MANDATORY SERVICE BULLETIN NO. MSB 42-003

Thielert Software m2.7
ATA-Code: 75-00

TR-MÄM-42-070

TAE SOFTWARE 2.7

CLIMB PERFORMANCE - TAKE-OFF CLIMB

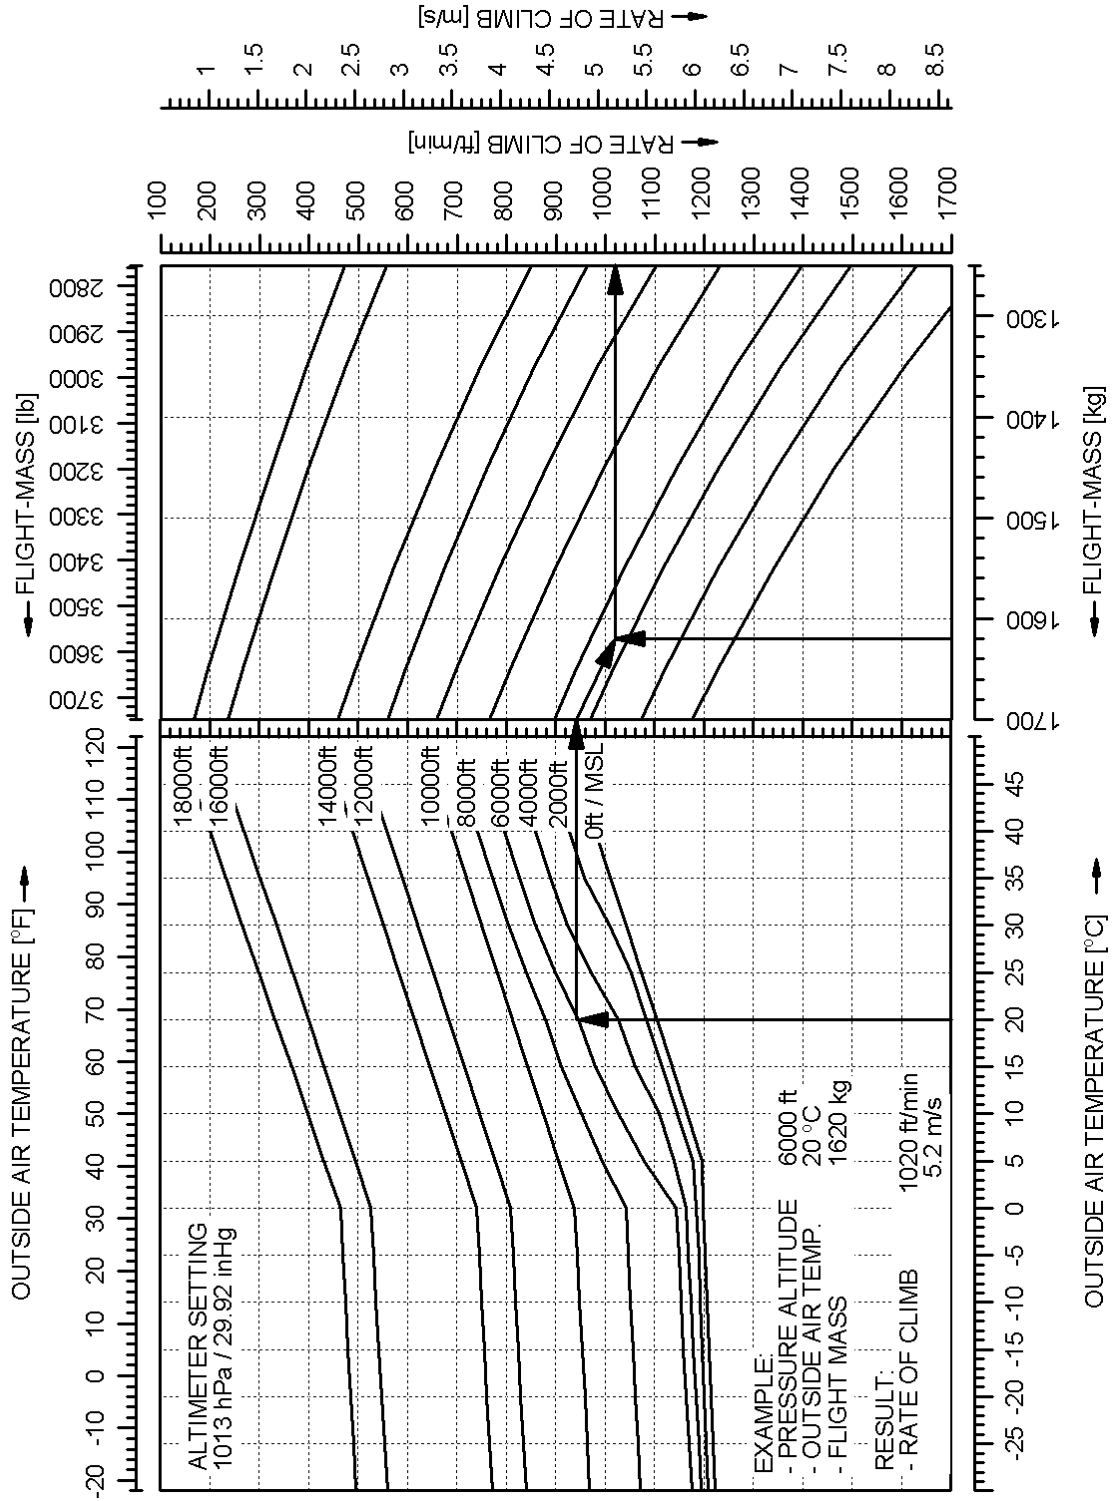
Doc. No.	Section	Affected Pages
7.01.05-E	2	2-11a
	4B	4B-16a, 4B-17a
	5	5-11a, 5-12a, 5-14a, 5-16a, 5-18a
	7	7-28a, 7-51a, 7-56a
